UNITED STATES PATENT AND TRADEMARK OFFICE

APPLICATION NO.	FILING DATE	FIRST NAMED INVENTOR	ATTORNEY DOCKET NO.	CONFIRMATION NO.
09/783,375	02/14/2001	Douglas Michael Johnescu	BERG-2572/C2685	2317

Office Action Summary

DETAILED ACTION

Attachment 1

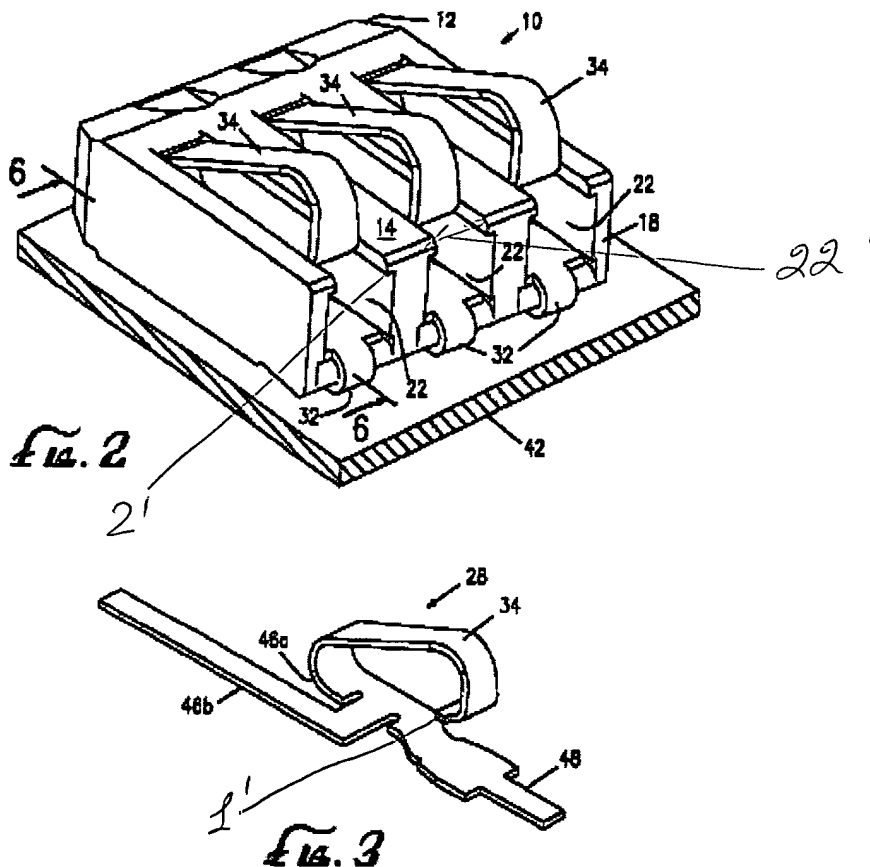
Kwait does not discuss the contacts preloaded but includes the structure that provides it, such as **ears** (1') on the distal end of a portion 34 and **shoulders** (2') on the top of the compartment 22 and top wall 14 (see Figs. 2 and 3 in the attachment 1).

In regards to claim 32, the contacts are compressed to insert a tab 34 into associated opening 22' in the housing formed by shoulders 2' (see Figs. 2 and 3 of ^{attached drawing)} ~~an attachment~~ 4):

Kwait does not discuss the contacts preloaded but includes the structure that provides it, such as **tabs** (1') on the distal end of portion 34 and **shoulders** (2') on the top of the compartment 22 and top wall 14 (see Figs. 2 and 3 in the attachment 1).

In regard to claim 19, the housing comprises a retention structure 2' (see attachment 1, Fig. 2).

In regard to claim 20, each contact 28 includes a medial section (not labeled, an area abuts a wall 16), a mounting portion 32, and a compressive mating portion 34 having a distal end, wherein the retention structure 2' (see attachment 1) engages the distal ends (not labeled, lower part of mating portion 34) to preload the contacts (see Figs. 1 and 2).
